SUDAS Revision Submittal Form

Status Date:	As of 10/23/2026	**Topic:**	Partial depth patch
Manual:	Specifications	**Manual Location:**

FIGURE 7040.104

PARTIAL DEPTH PATCHES

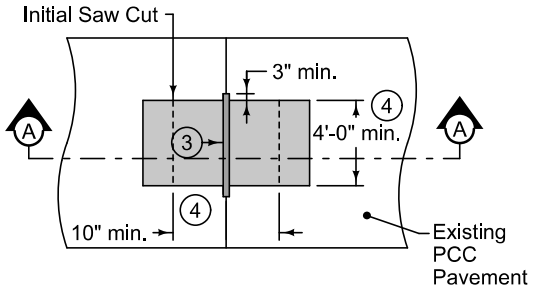
Requested Revision: *See attached.*

Reason for Revision: Correction from minimum 10 inch width each side of joint to 10 inch width total (both sides of joint).

Comments: Revision will match the *Concrete Pavement Preservation Guide*.
